Thornleigh Station Upgrade

Determination Report

April 2021

Figure 3 Revised key features of the Proposed Activity (indicative only, subject to detailed design)

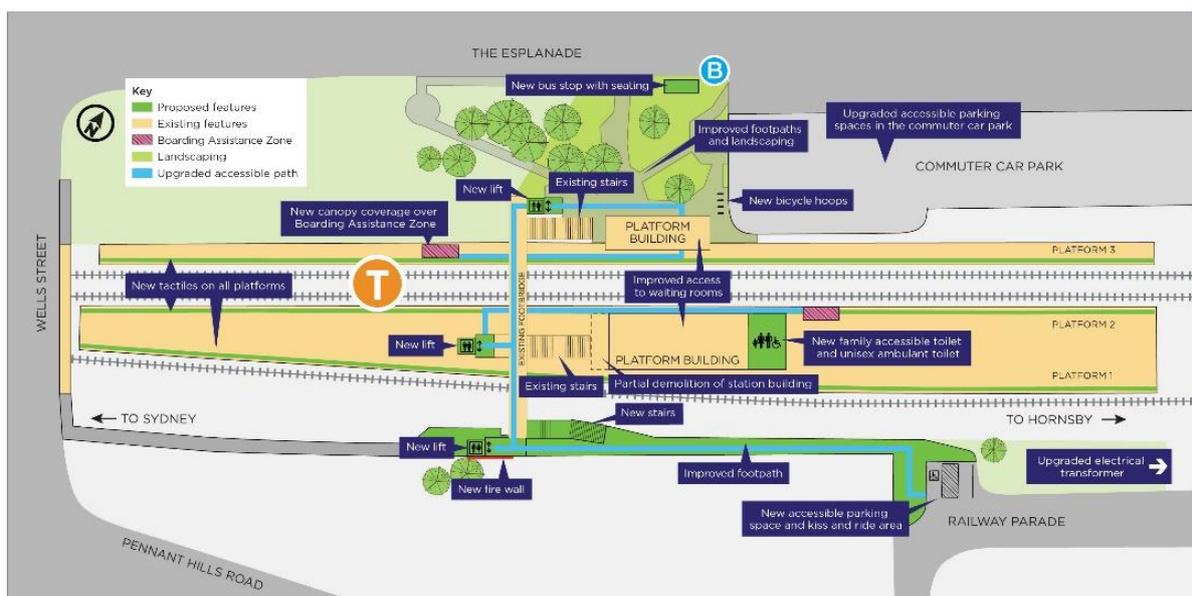
Aspect of the Proposed Activity	Design change	Discussion of impacts
Installation of electrical transformer	Installation of a new three phase 200kVA 415V isolation transformer	<p>The new transformer would be located near the Railway Parade access gate to the rail corridor as shown in Figure 3.</p> <p>Noise and Vibration</p> <p>The proposed transformer is located in the general vicinity of the remaining station upgrade works and would require similar equipment for construction as that outlined in the REF. As such the construction noise and vibration impacts would be similar to those assessed in Section 6.3 of the REF.</p> <p>Operational noise from the transformer is unlikely to provide more than a negligible noise contribution to the existing noise environment at the station, and therefore would not have an additional impact to nearby residential receivers.</p> <p>Visual amenity</p> <p>The new transformer would be located within the rail corridor and screened by existing corridor vegetation. As such, no additional visual impacts beyond those assessed in the REF are anticipated.</p> <p>Biodiversity</p> <p>No removal of vegetation would be required.</p>

Fire wall installation	Installation of a fire wall along the boundary fence at the location of the Railway Street lift	<p>To comply with fire safety requirements, a fire wall would be installed along the boundary fence at the Railway Street lift for a length of approximately 12 metres. The proposed fire wall would have a height of approximately 6.5 metres above ground level.</p> <p>Visual amenity</p> <p>The additional fire wall would have a moderate visual impact on the station precinct and to neighbouring commercial properties. However, the wall would ensure fire safety for adjoining commercial sites from any fire incidents associated with the lift and is required to be adjacent to any lift openings.</p>
